Subject: Airport Conflict Evaluation
Arizona Commerce Center
Southeast Corner of Arizona Avenue and Ryan Road

Staff recommends the Airport Commission ("Commission") present an Airport Conflict Evaluation (ACE) report to the Zoning Administrator and City Council with a finding of "no conflict with airport uses" for the proposed Arizona Commerce Center development.

Exhibit C: Site Plan

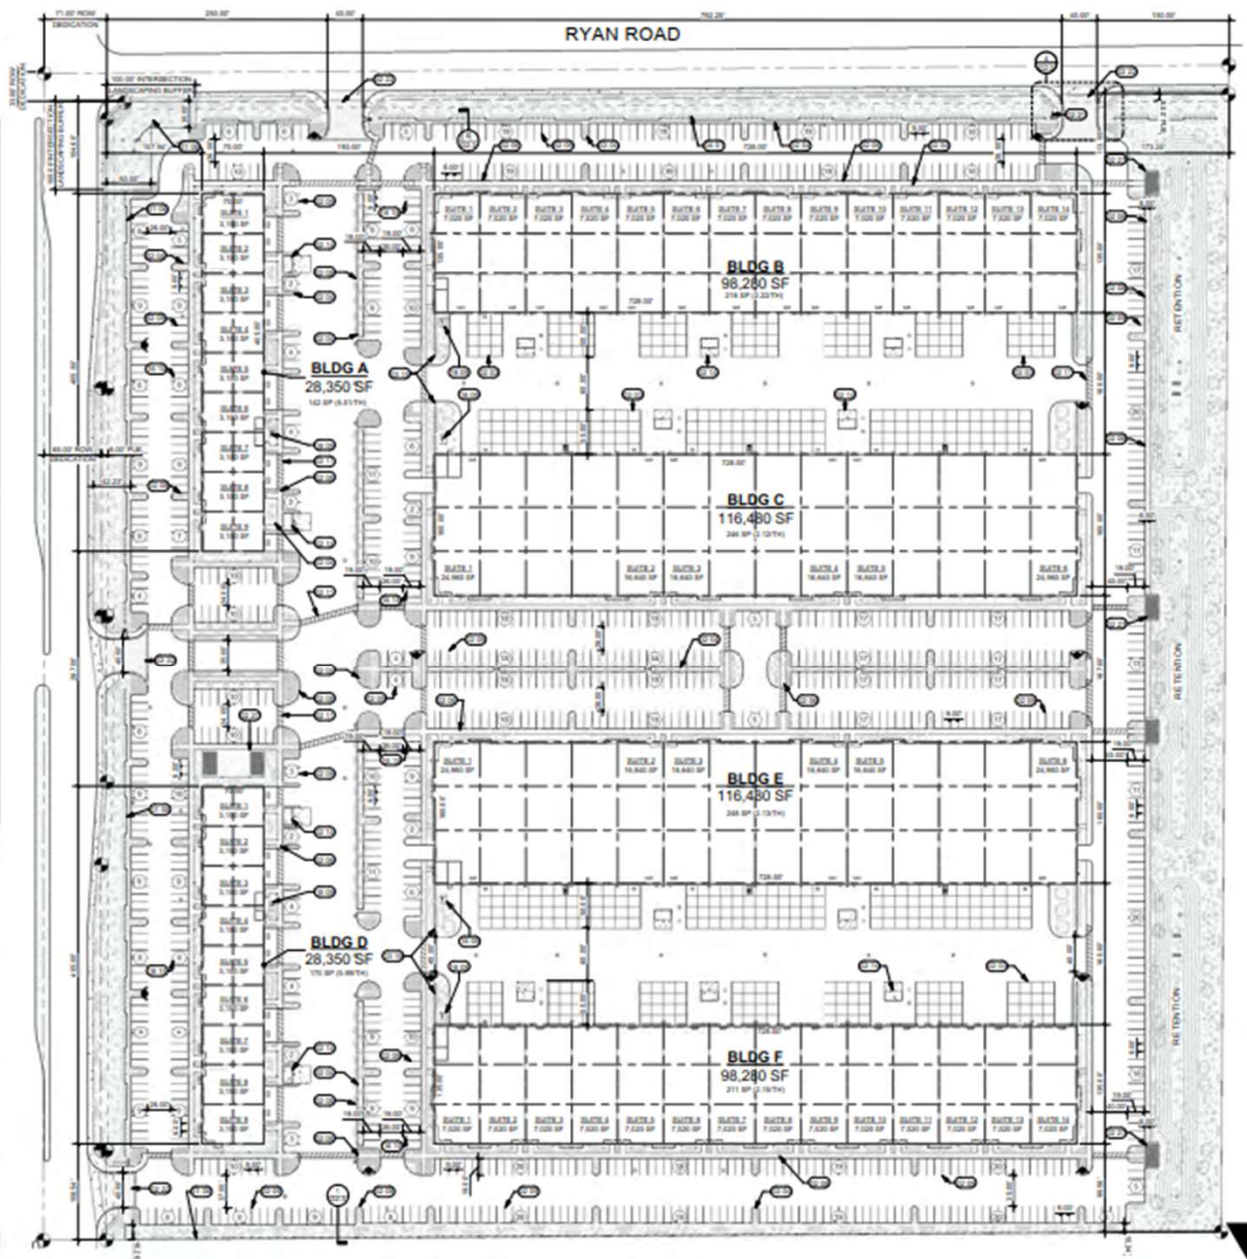
The six buildings will consist of approximately 486,000 square feet (SF) (*Exhibit C - Site Plan*). The proposed building heights will be 34 feet for Buildings "A" and "D" fronting Arizona Ave with the remaining four buildings not exceeding 45 feet.

Based on the proposed building heights, the proposed development does not appear to pose a hazard to flight safety or be an airspace obstruction. The proposed building height does not appear to impact the approach and departure surfaces for either runway. *Final building structures, including all rooftop objects, must not impact the approach and departure surfaces for the Airport's runways.*

*The owner/applicant must file a Notice of Proposed Construction (FAA Form 7460-1) with the Federal Aviation Administration (FAA) for the **final structure heights**, including, without limitation, all rooftop antennas, parapets, light poles, and other equipment.* The form may be submitted online at the FAA's Obstruction Evaluation/Airport Airspace Analysis (OE3A) website. The FAA-assigned numbers for all evaluation cases must be provided to Airport Administration.

Exhibit E: Flight Tracks

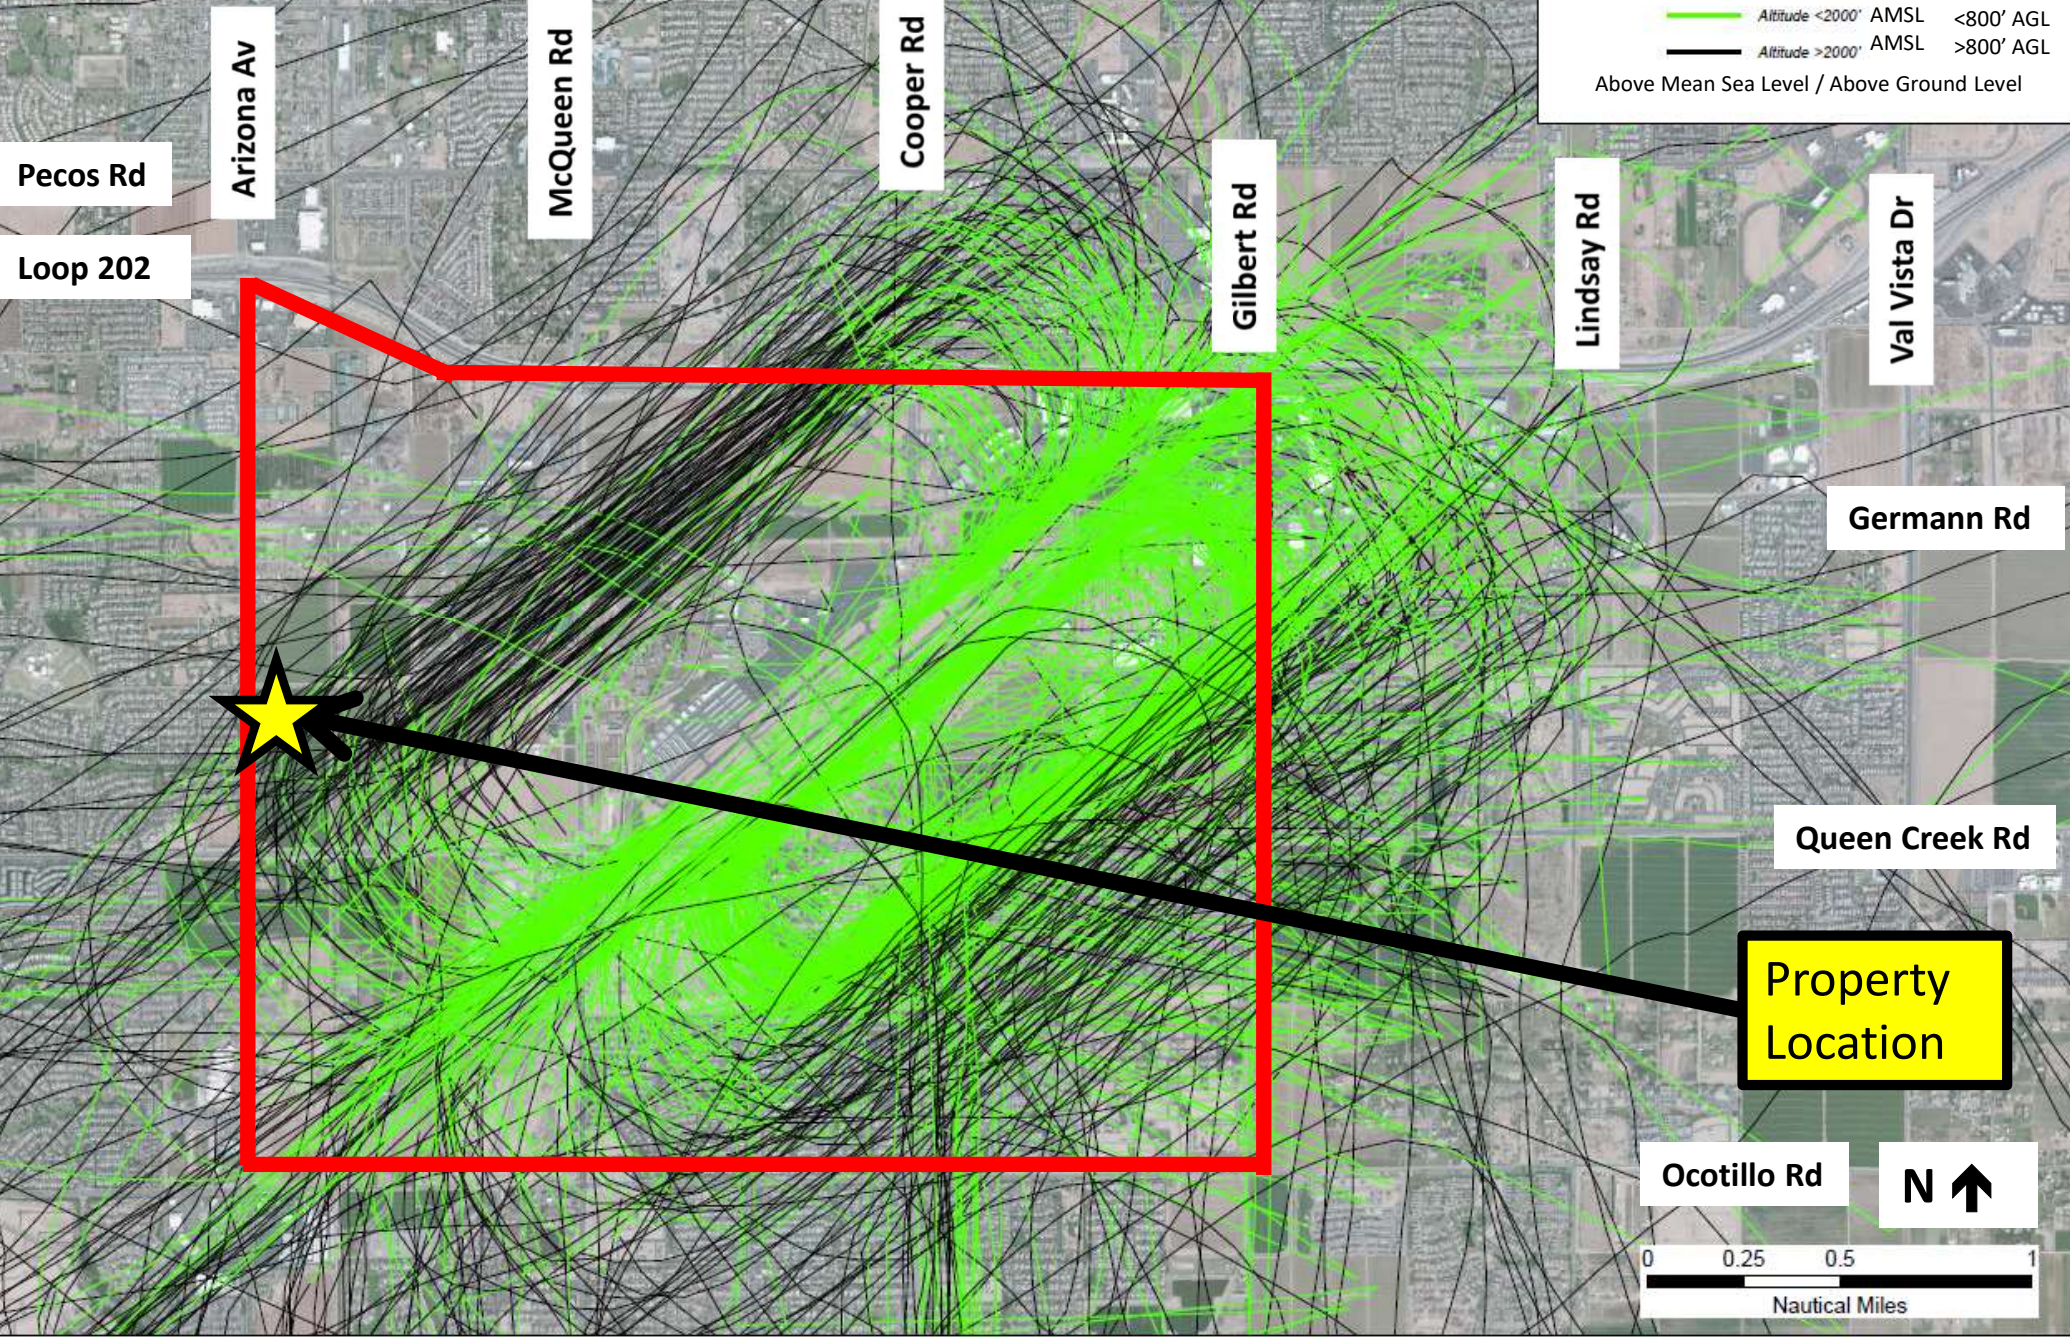
The proposed development is consistent with the CAAP. Commercial and industrial land uses are generally compatible with airport operations. The property will experience daily overflights from aircraft on takeoff and landing (*Exhibit E - Flight Tracks*).

Exhibit F: Building Elevations

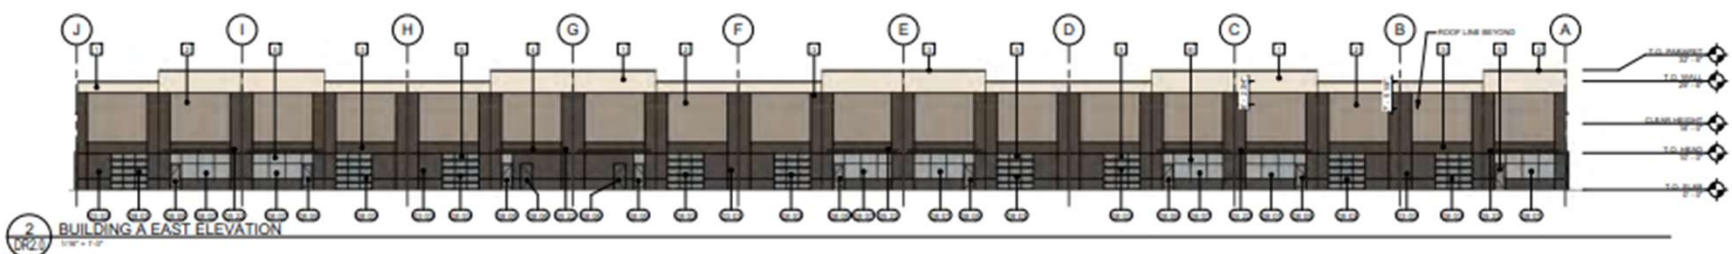
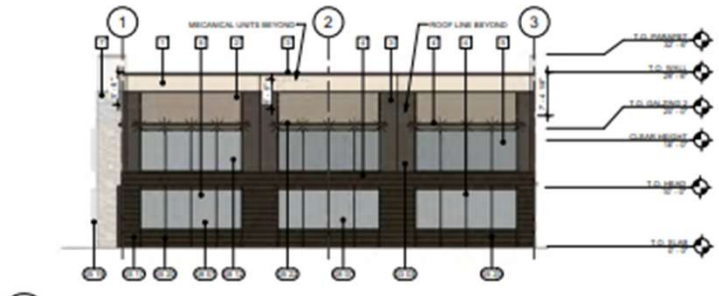
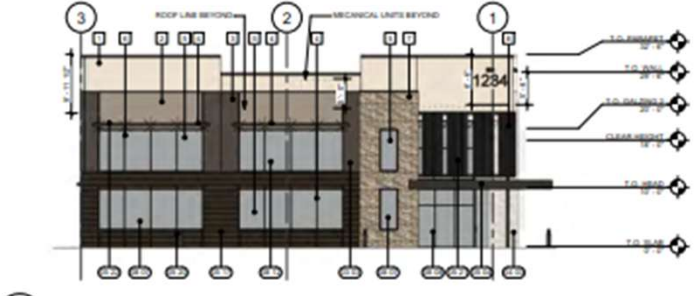
The proposed project's building design must not create reflectivity issues with aircraft in the traffic pattern and on approach or takeoff (*Exhibit F – Building Elevations*). The use of non-reflective glazing and non-reflective paint is encouraged.
